MCB Insertion Loss

D2.2 Comment #232

IEEE 802.3dj Task Force
November 2025

Figure 179A-1—Host-Nominal to Host-Nominal, Cable assembly, and test fixture insertion loss at 53.125 GHz

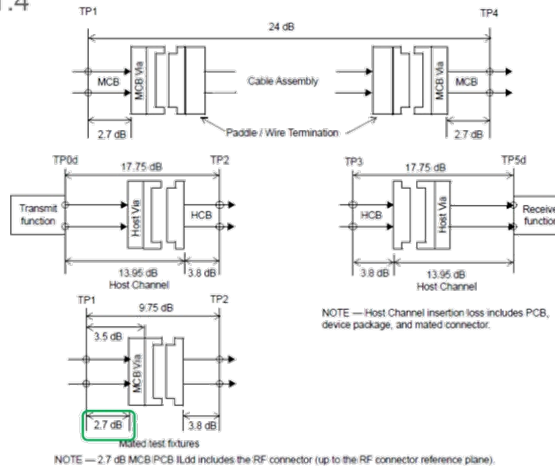
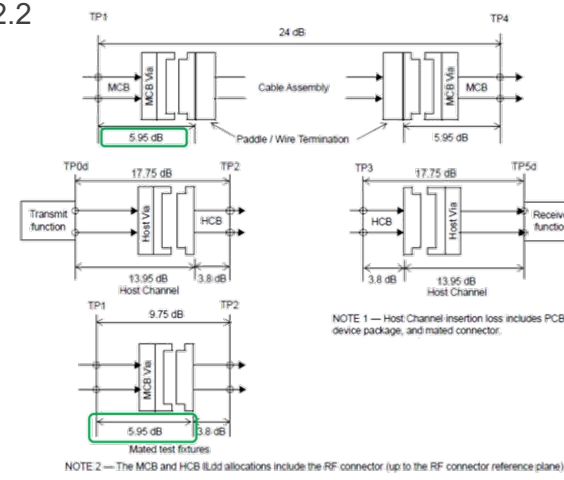
- MTF informative IL specification changed @ D1.5.
 - This is a fundamental methodology change from prior generations to clearly define MTF performance.
 - This had the consequence that connector and via improvements are absorbed into the test fixture and don't benefit cable, module or host.
- 07/25 and 09/25 meetings discussed the issue and built consensus over that period of time.
- This contribution provides a more thorough set of proposed changes that resulted from consensus building with a broad set of stakeholders through October.

Figure 179A-1—Host-Nominal to Host-Nominal, Cable assembly, and test fixture insertion loss at 53.125 GHz

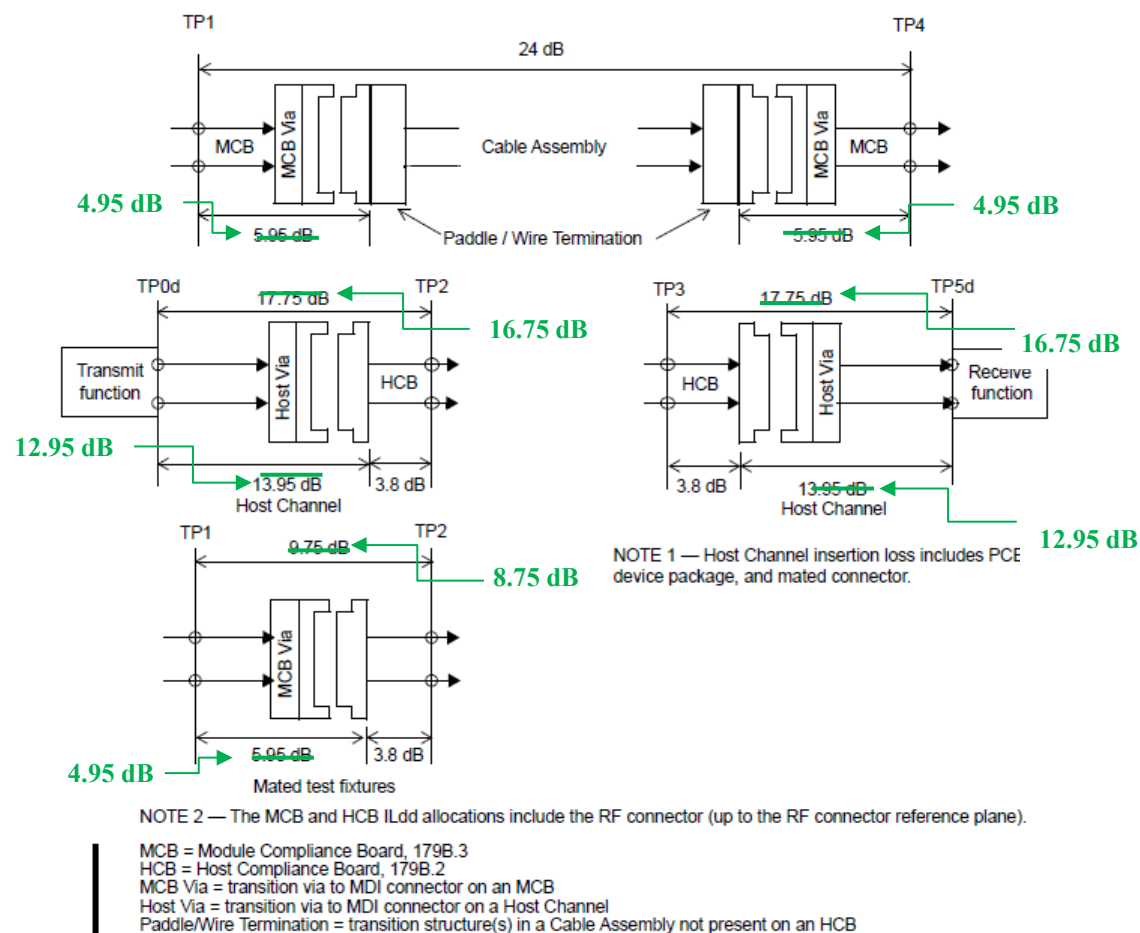
Location	Description
Figure 179A-1	Reduce insertion loss by 1 dB: • TP1-connector (2x) & connector-TP4 (1x) • TP1-TP2 (1x) • TP0d-connector (1x) & connector-TP5d (1x) • TP0d-TP2 (1x) & TP3-TP5d (1x)
Figure 179A-2	Reduce host channel insertion loss by 1 dB (2x). Modify budget equation to reflect the IL changes.
Table 179A-1	Reduce maximum insertion loss for all 3 host classes by 1 dB for host channels and for TP0d-TP2/TP3-TP5d.
Table 179A-2	For all link configurations in the table reduce • (Column 3) Ildd_TP0d-TP2,max by 1 dB • (Column 4) Ildd_TP3-TP5d,max by 1 dB • (Column 5) Ildd_MTFref by 1 dB
Table 179A-3	Reduce Ildd_MTFref by 1 dB. Modify budget equation to reflect the IL changes.
Table 179-7	Change R_peak to account for change in IL (1 dB host loss)
Table 176D-3	Change R_peak to account for change in IL (1 dB MCB loss)
Table 176D-6	Change partial host trace lengths to account for reduced connector loss. Comment #204 proposes to change it to 280 mm.

Figure 179A-2—HN-to-HN Channel Max (TP0d-TP5d) at 53.125 GHz

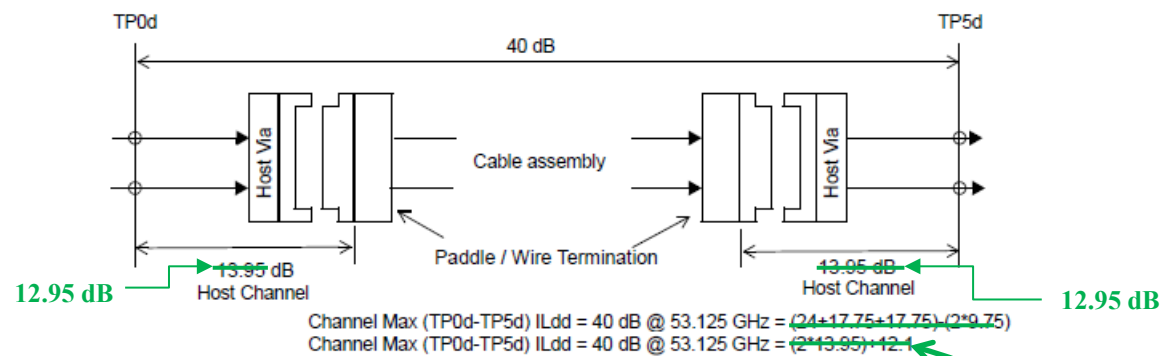
Channel Max (TP0d-TP5d) ILdd = 40 dB @ 53.125 GHz = (24+16.75+16.75)-(2*8.75)
 Channel Max (TP0d-TP5d) ILdd = 40 dB @ 53.125 GHz = (2*12.95)+14.1

Figure 179A-3— Channel Min (TP0d-TP5d) at 53.125 GHz

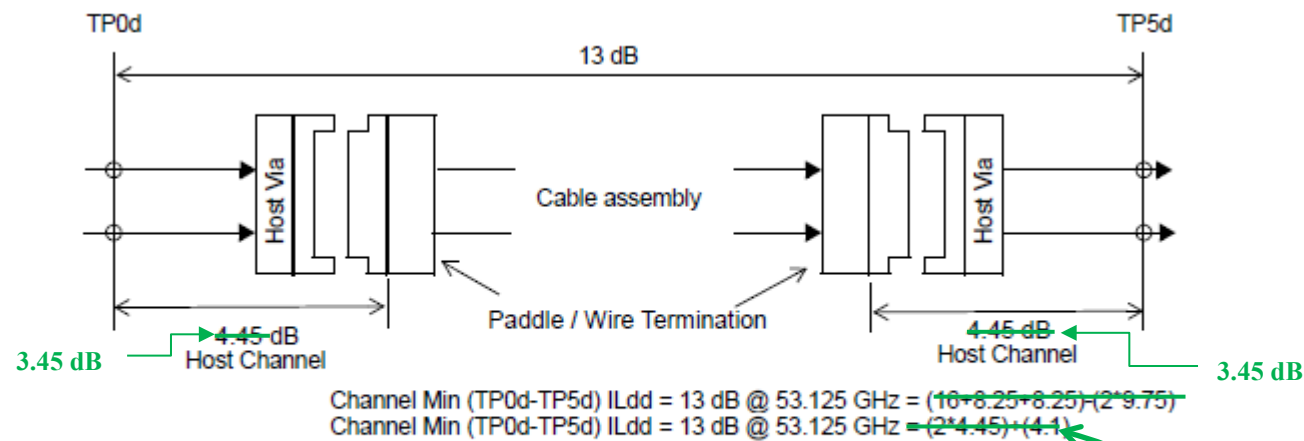
Channel Min (TP0d-TP5d) ILdd = 13 dB @ 53.125 GHz = (16+7.25+7.25)-(2*8.75)

Channel Min (TP0d-TP5d) ILdd = 13 dB @ 53.125 GHz = (2*3.45)+6.1

Proposed Changes: 179B Equations & Figures

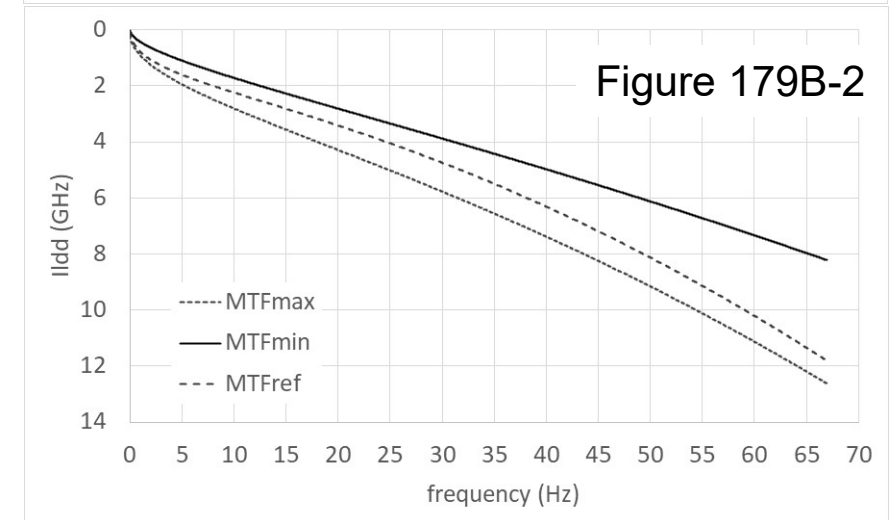
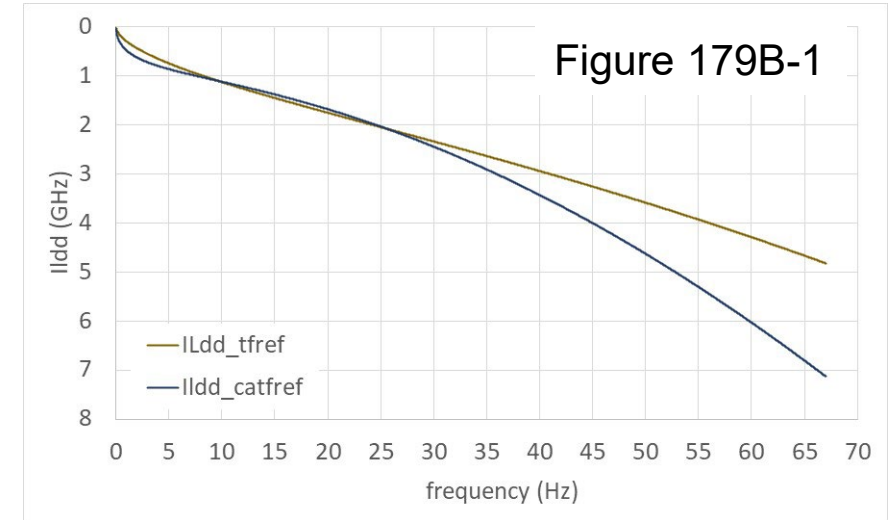
Location	Description
Equation (179B-2)	Modify to reflect change in insertion loss.
Equation (179B-3)	Modify to reflect change in insertion loss.
Equation (179B-4)	Modify to reflect change in insertion loss.
Equation (179B-5)	Modify to reflect change in insertion loss.
Figure 179B-1	Update to reflect change in (179B-2)
Figure 179B-2	Update to reflect change in (179B-3), (179B-4), (179B-5)

$$ILdd_{catref}(f) = -0.0269 + 0.65\sqrt{f} - 0.165f + 0.02325f^{1.5} \quad (179B-2)$$

$$ILdd(f) \geq ILdd_{MTFmax}(f) = 0.1 + 0.8\sqrt{f} + 0.0055f + 0.00125f^2 \quad (179B-3)$$

$$ILdd(f) \geq ILdd_{MTFmin}(f) = 0.3854\sqrt{f} + 0.0455f + 0.00045f^2 \quad (179B-4)$$

$$ILdd_{MTFrefTF}(f) = -0.0419 + 0.93\sqrt{f} - 0.13005f + 0.0183f^{1.5} + 0.00065f^2 \quad (179B-5)$$
